37/3-prelim 7219 Spruce Avenue
Takoma Park Historic District

HISTORIC PRESERVATION COMMISSION STAFF REPORT

Address: 7219 Spruce Avenue Meeting Date: 5/12/93
Resource: Takoma Park Historic District Preliminary Consultation
Case Number: n/a Tax Credit: No
Public Notice: 4/28/93 Report Date: 5/5/93
Applicant: J. Hurst/J. Murphy Staff: Nancy Witherell
PROPOSAL: Addition RECOMMEND: Option B

Option A
7219 Spruce

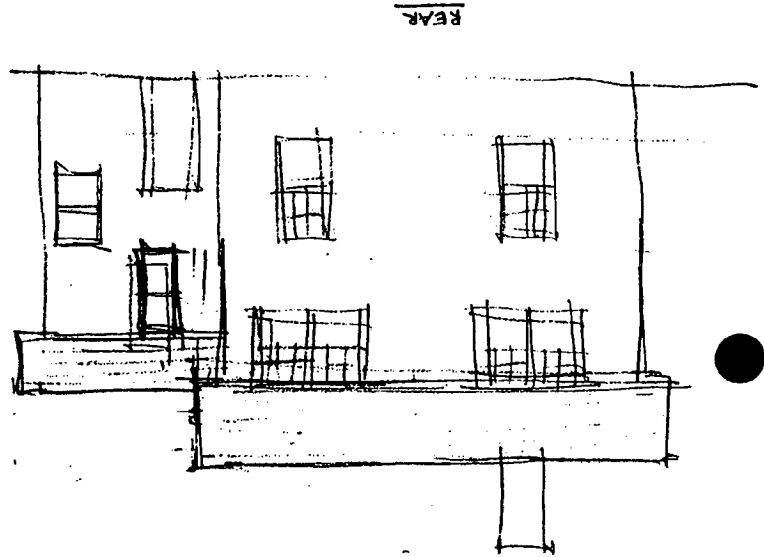
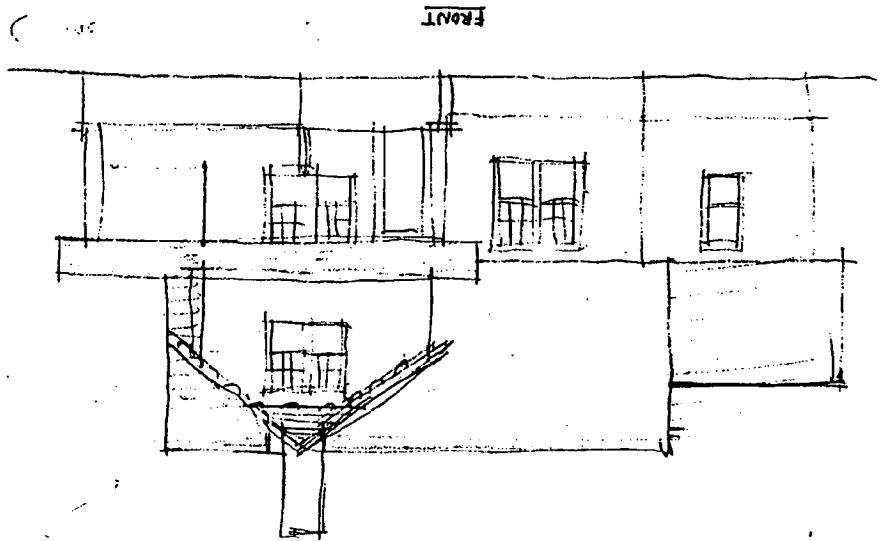
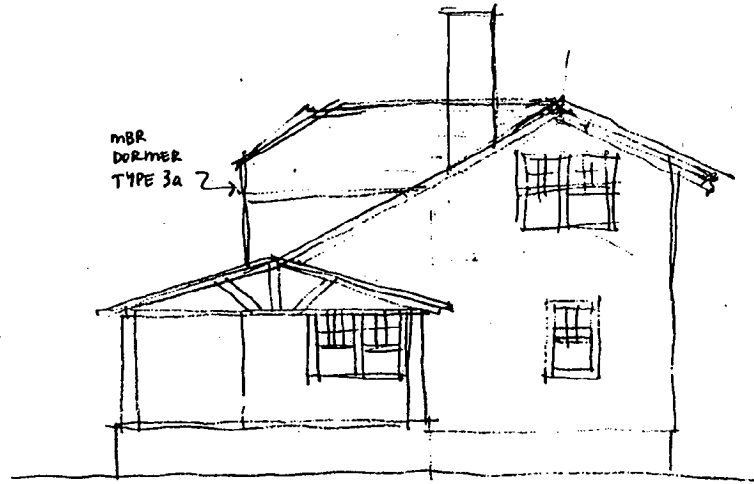
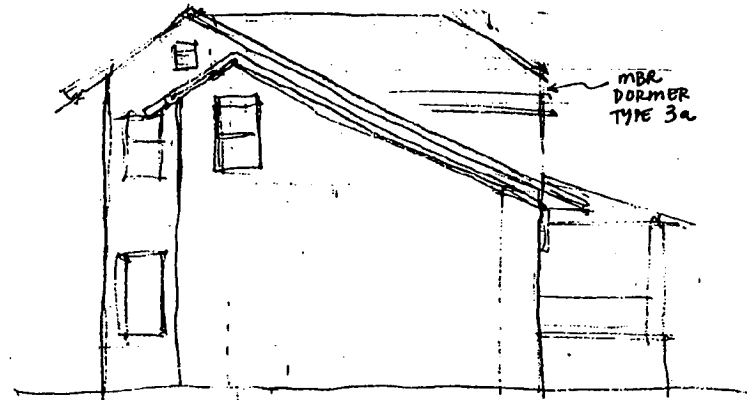
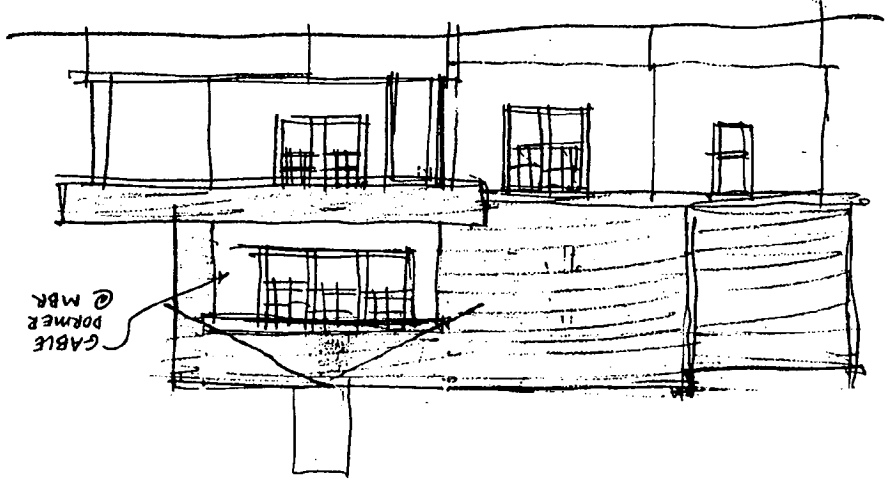
Option A retains the existing roof slope, pushing the ridge farther back on the house. Shed dormers are shown on the model; a sketch of a jerkinhead dormer on this roof is shown in the accompanying materials. Option B raises the pitch of the roof, but maintains the ridge in the center of the house. A gabled front dormer and a shed rear dormer have been shown on the model.

Of these two basic options, the staff prefers Option B, which in the staff's judgment, is more similar to the existing house and more consistent with the Takoma Park guidelines. The guidelines recommend the retention of the character of the house and its style; in the staff's judgment, Option A changes that character too much, especially through the use of an off-center gable ridge and an elongated dormer.

Option B
 7219 Spruce

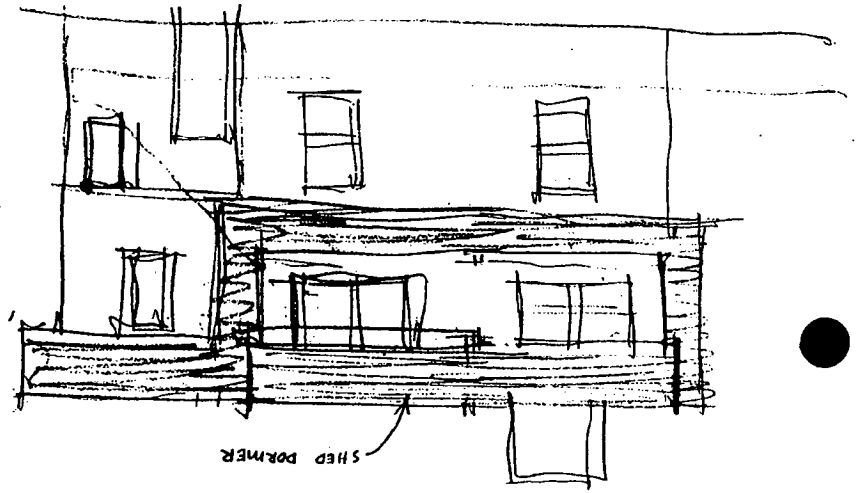
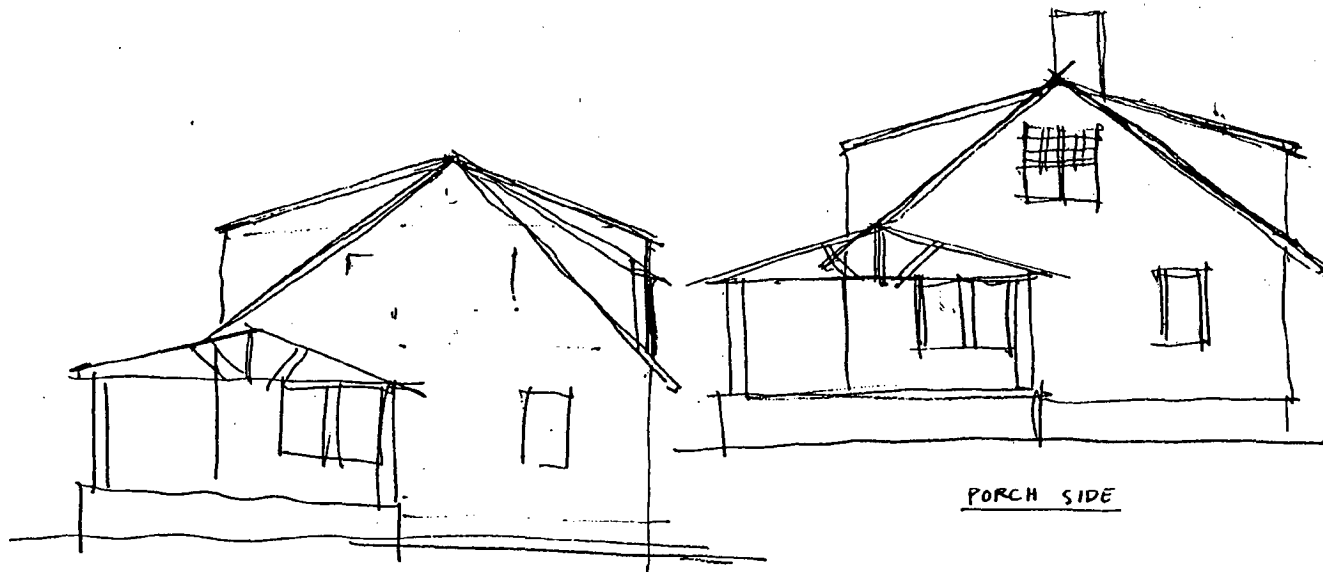
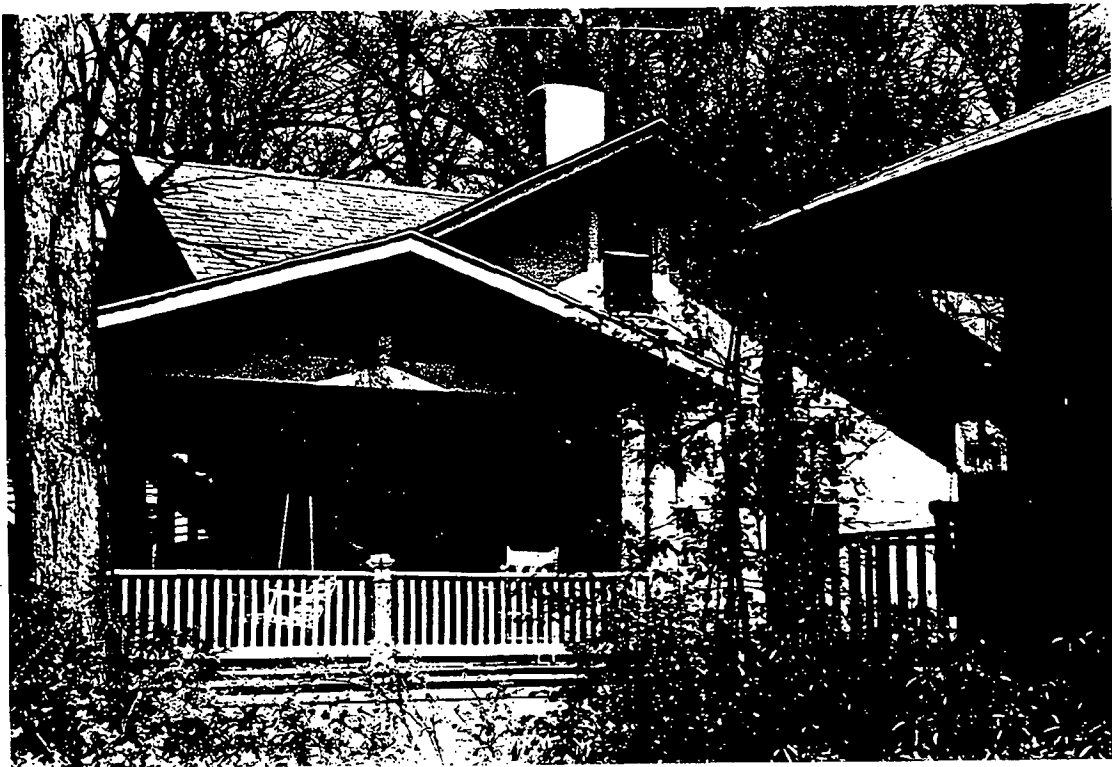
Even though the Commission has recommended against changing the roof pitch in previous cases of a similar nature in Takoma Park, the staff recommends that this option be given preference in this case.

The staff recommends that the applicants proceed with plans for Option B, using a gabled dormer at the front and a shed dormer at the rear. The staff finds this approach to meet the intent of the Takoma Park guidelines for small houses.
